Product Change Notification

Change Notification #:	111212 - 00
Change Title:	Intel Ethernet Server Adapters X520-T2, E10G42BT/BTG1P5 (Iron Pond Retail/OEM generic), Intel 10 Gigabit CX4 Dual Port Server Adapter, EXPX502CX4 (Cedar Cove Retail) and Intel 10 Gigabit XF SR Server Adapters, EXPX9501AFXSR/SRGP5 (Bellefontaine Retail/OEM generic) PCN 111212-00 Label OUI block change
Date of Publication:	December 19, 2011

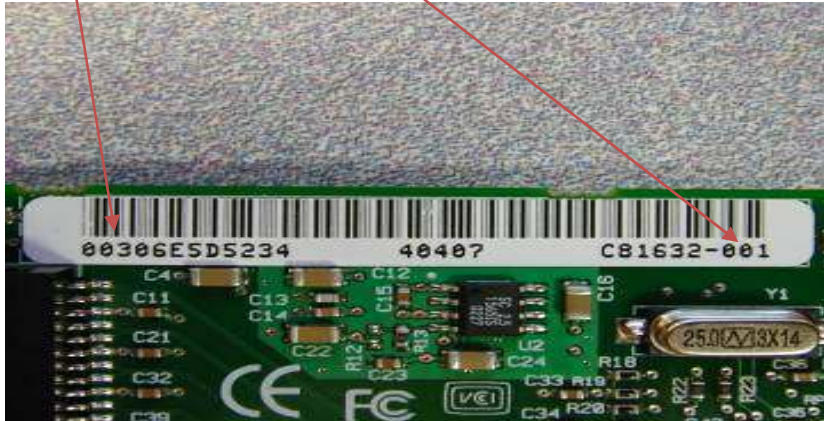
3n1 label change: The 3n1 label will change to reflect the new OUI Block number and PBA# dash roll (printed board assembly), as show in the picture below. The 3n1 label is placed on the Front side of the Printed Board. (picture example only)
